BYLAW C-8193-2021

A bylaw of Rocky View County, to amend the South Conrich Conceptual Scheme Bylaw C-6401-2006.

SCHEDULE 'A'
FORMING PART OF BYLAW C-6401-2006

Appendix: Cell D

Figure 8: Conceptual Land Use Plan

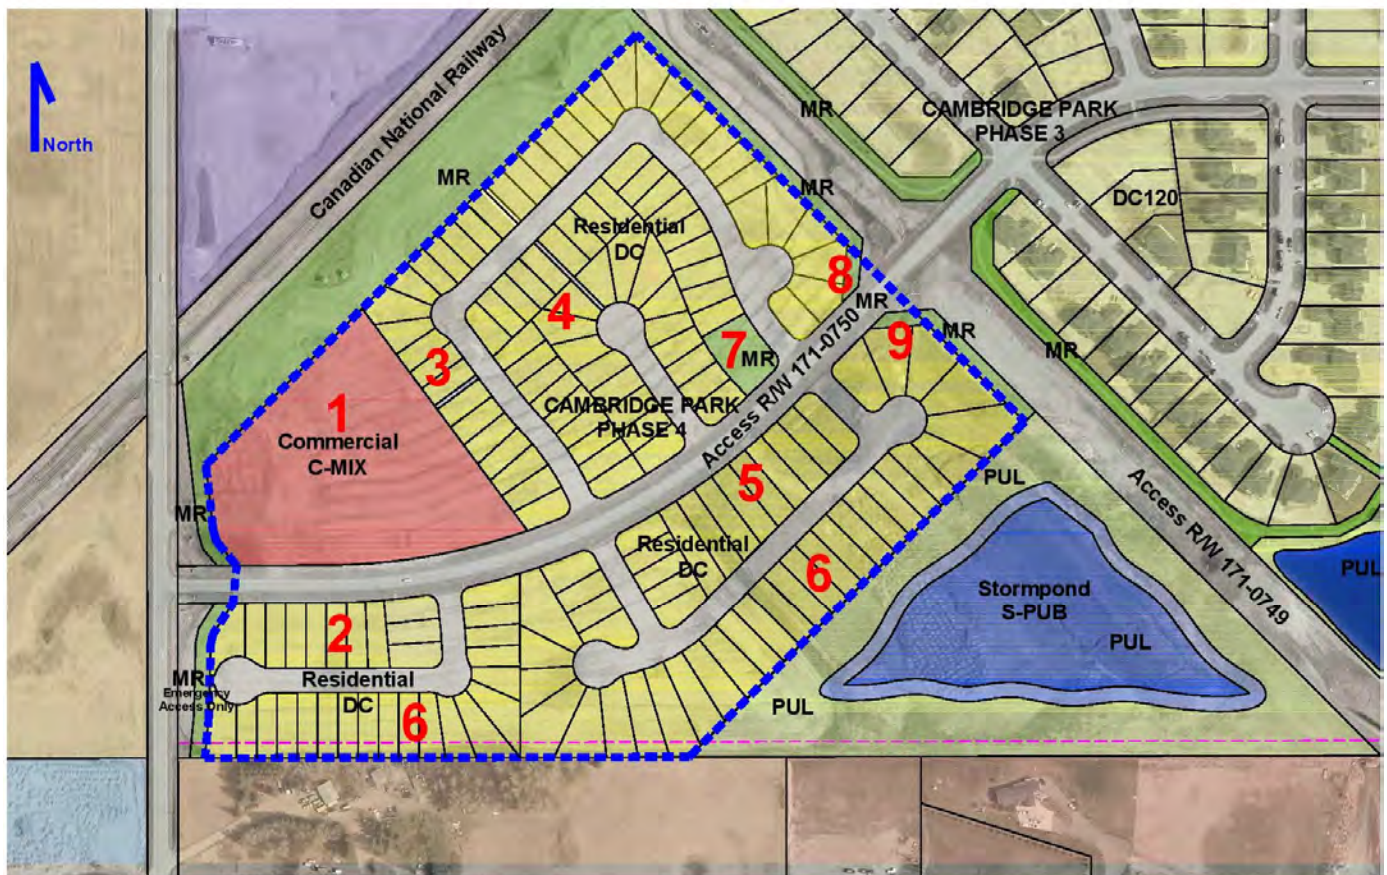
- ~~7.0.27.0.~~ Subdivision of land within Cell D should generally be in accordance with ~~the conceptual design provisions of~~ Figure 8 - Conceptual Land Use Plan ~~herein~~.

- ~~7.0.3~~ The following items shall apply for all residential parcels ~~shown~~ referenced as 2, 3, 4, 5, and 6 on Figure 8 - Conceptual Land Use Plan:

Figure 10: Modified Road Cross-Sections

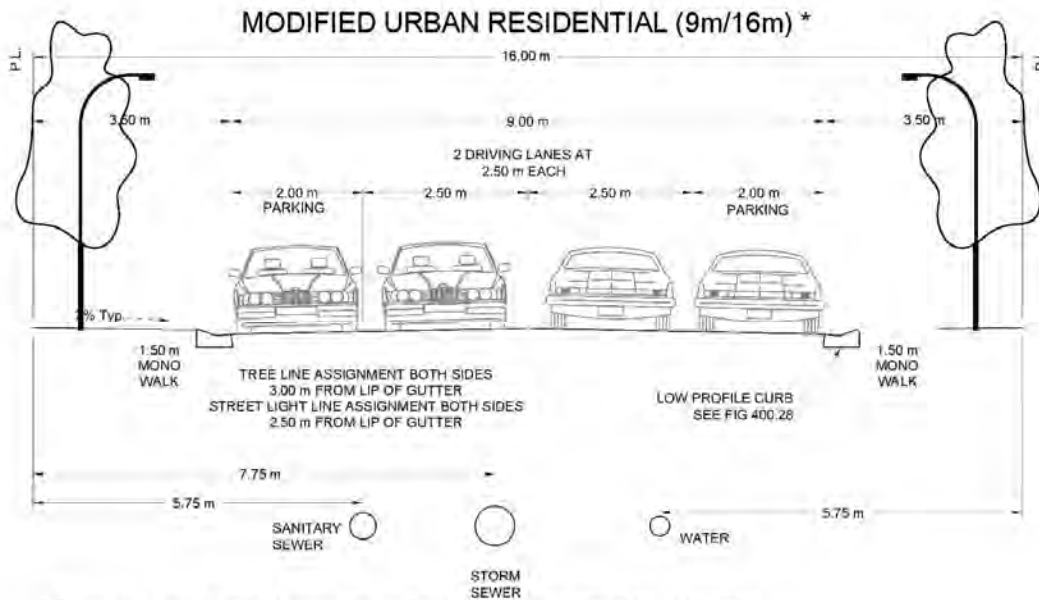
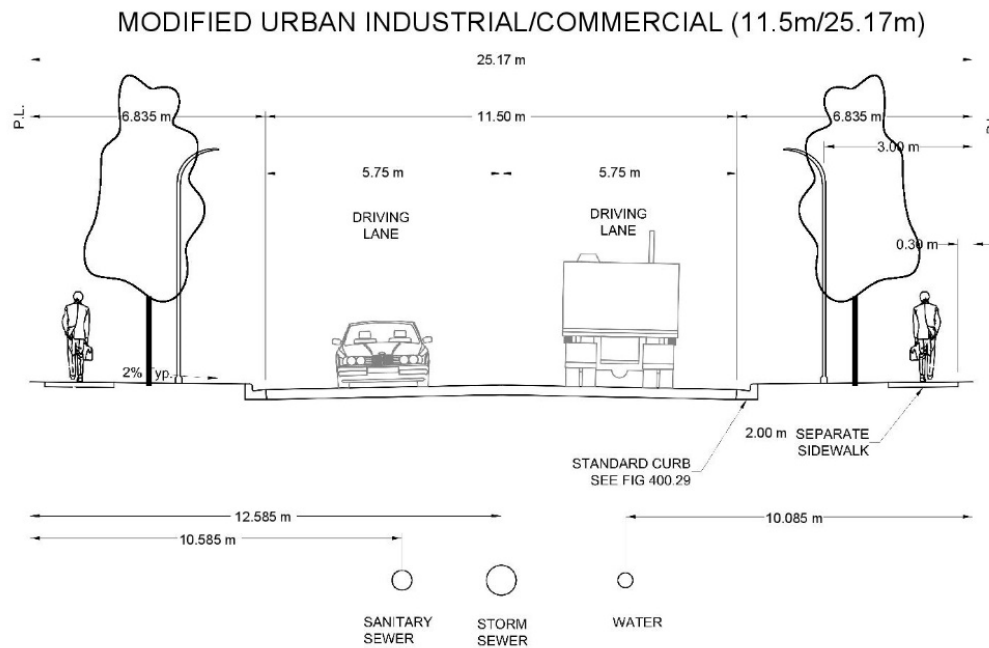
- 8.0.4 *~~Notwithstanding 8.0.2, any modifications proposed to public roads such as those shown in Figure 10: Modified Road Cross-Sections, shall be considered by the County.~~ Notwithstanding 8.0.2, any modifications proposed to public roads such as those shown in Figure 10 – Modified Road Cross-Sections, shall be considered by the County.*

Figure 10 - Landscaped Area Plan

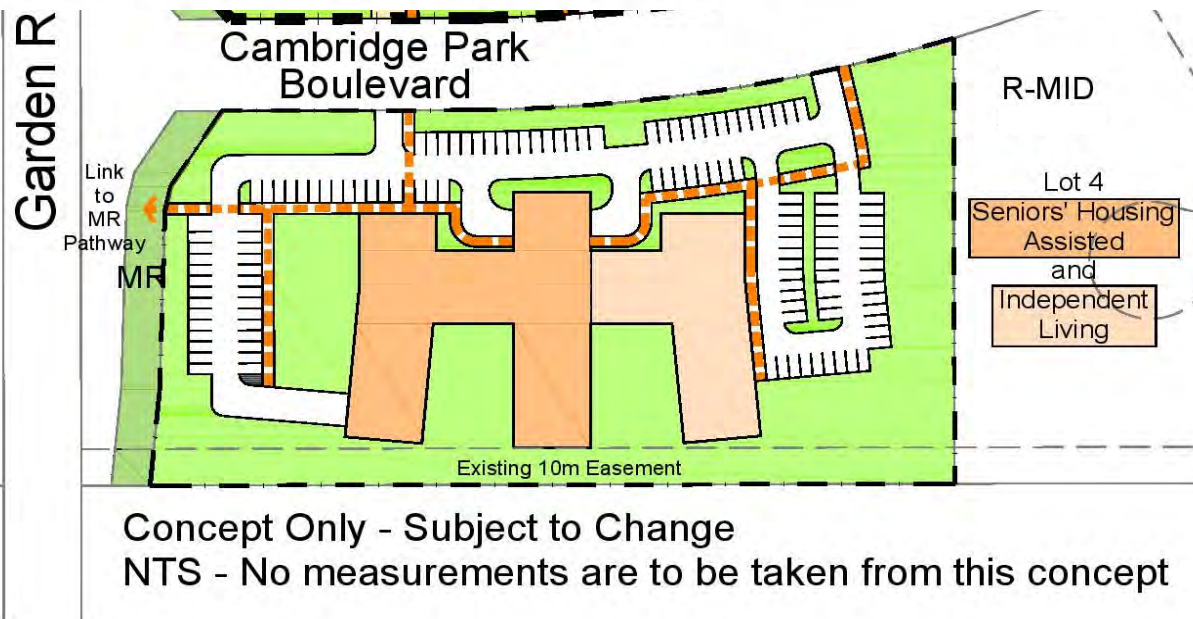
- ~~7.0.4 A landscaped area of a minimum 5.5 Metres (18 Feet) shall be provided on lots as identified in Figure 9 – Landscaped Area Plan. The vegetation shall contain mainly large caliper trees but may also contain shrubs. Native species are preferred~~
